Access Compliance Report

Public Rights-of-Way

(Curb Ramps)

Intersection ID: N/A	Main Street: LANGWELL_LN	Cross Street: INVERNESS_BAY_RD	Location: NE
ADA ID: 4FB60D016D9A	Ramp Type: Perp	Initial Pass/Fail: Fail	Overall Compliance: No
Codes/Mitigation Info/Possible Solution		Field Measurements/Component Compliance	
Severity Score: 33.75

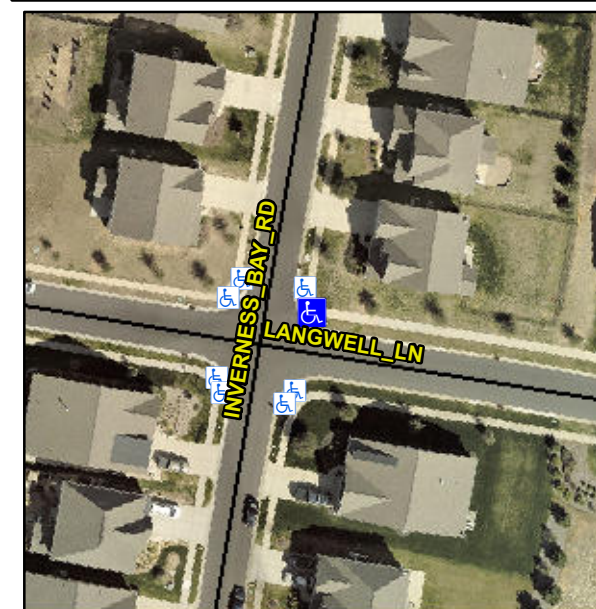
Not Found, R304.5.1, R304.5.3

Compliance	Description	Data	Compliance	Description	Data
N/A	Ramp Length (in)	50.0	Yes	Ramp Slope (%)	5.3
No	Ramp Width (in)	47.5	No	Ramp XSlope (%)	7.4
N/A	Flare Type LT	N/A	N/A	Flare Type RT	N/A
N/A	Flare Slope LT (%)	N/A	N/A	Flare Slope RT (%)	N/A
N/A	Flare Traversable LT?	N/A	N/A	Flare Traversable RT?	N/A
N/A	Landing Length (in)	N/A	N/A	DWS Provided?	N/A
N/A	Landing Width (in)	N/A	N/A	DWS Contrast?	N/A
N/A	Landing Slope (%)	N/A	N/A	DWS Length (in)	N/A
N/A	Landing X Slope (%)	N/A	N/A	DWS Full Width?	N/A
N/A	Landing Curb? (Y/N)	N/A	N/A	DWS Offset (in)	N/A
N/A	Shared Landing?	N/A			
N/A	Gutter Ponding?	N/A	N/A	Gutter Slope (%)	N/A
N/A	Gutter Lip Ht (in)	1.0	N/A	Gutter X Slope (%)	N/A
N/A	Painted X Walk1?	No	N/A	Painted X Walk2?	N/A
	X Walk 1 Direction	To SW		X Walk 2 Direction	N/A
N/A	X Walk 1 Width (in)	N/A	N/A	X Walk 2 Width (in)	N/A
	X Walk 1 Slope (%)	0.2		X Walk 2 Slope (%)	N/A
	X Walk 1 X Slope (%)	2.5		X Walk 2 X Slope (%)	N/A

Remove & Replace Entire Ramp.
